SERVICE LETTER 181

7000A BULKHEAD 16 GUSSET BRACKET REPLACEMENT

Aircraft Makes/Model(s):	Float Model(s):	Compliance: Optional	By: RCG
Quest Kodiak 100	7000A	Part Number: 1009425	Approved: CAS
		Date: 11/27/2018	Revision: A

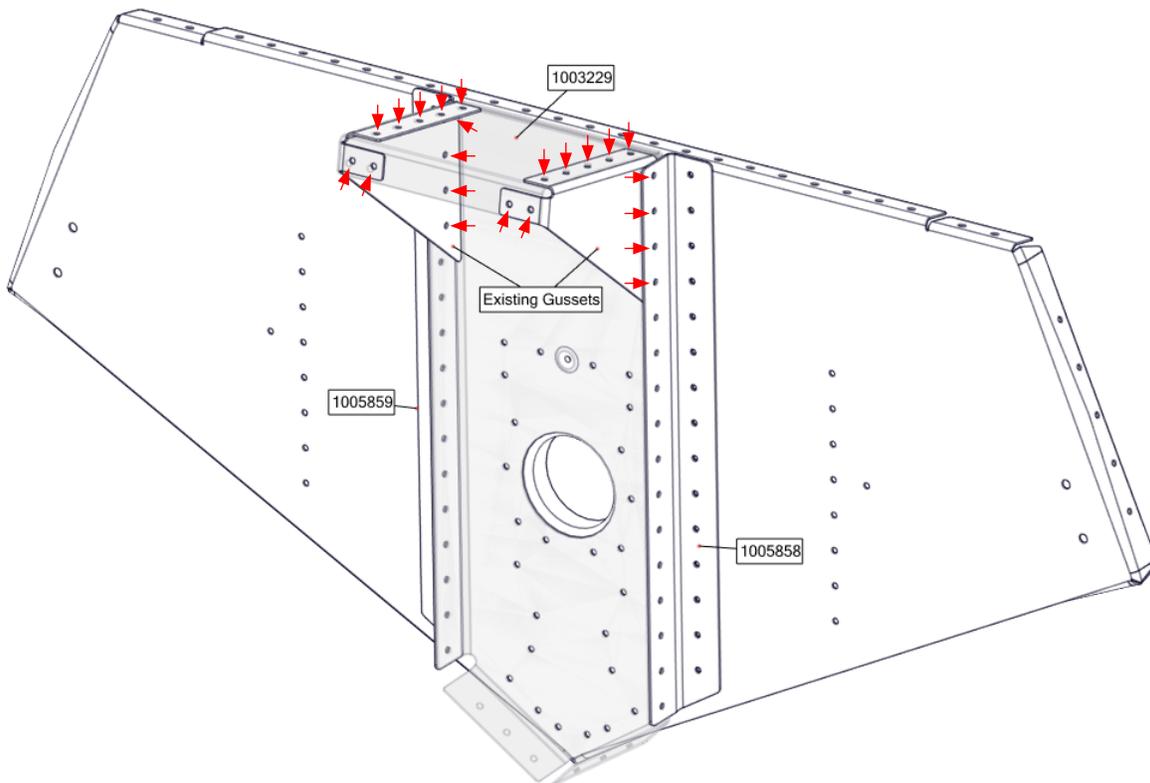
3. Drill out rivets that attach the existing gussets to the top deck (not shown), 1003229 water rudder pivot doubler, and 1005858 and 1005859 water rudder doubler angle supports as shown

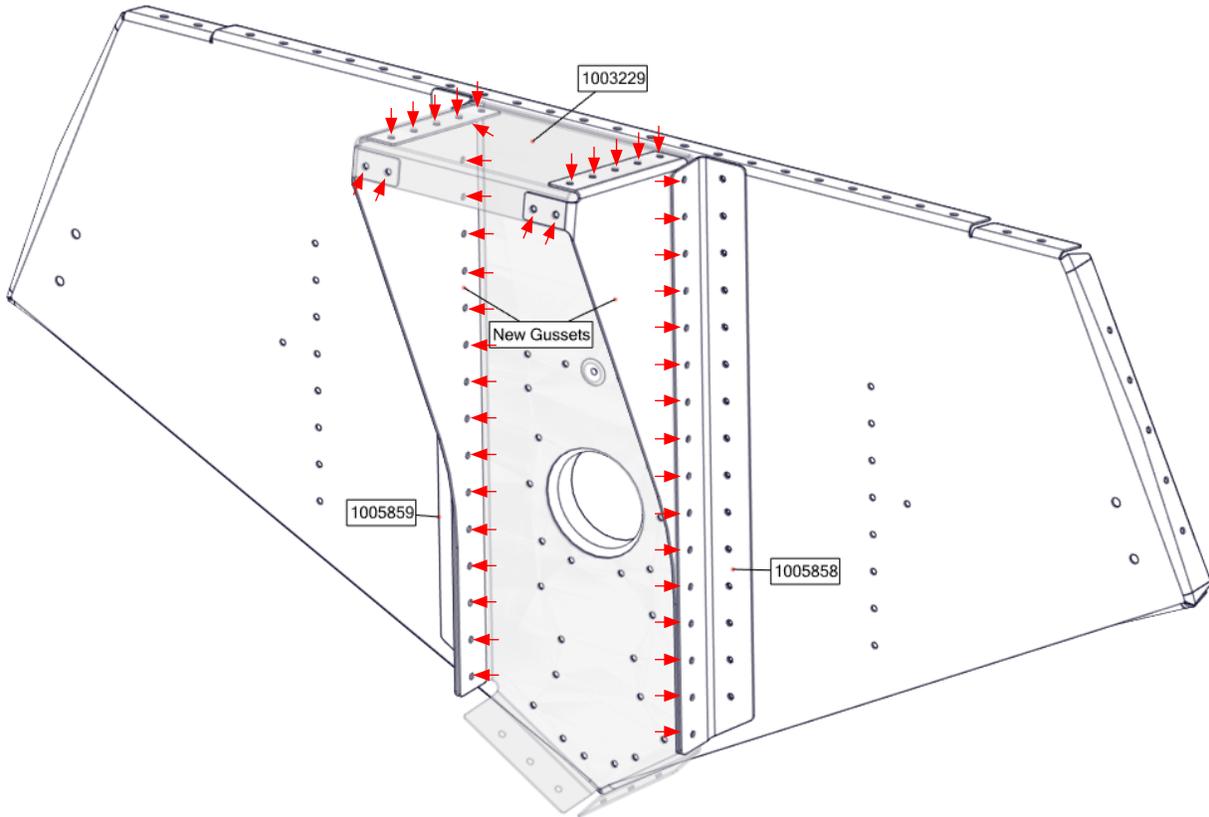
4. Remove existing gussets and rivet new gussets where shown
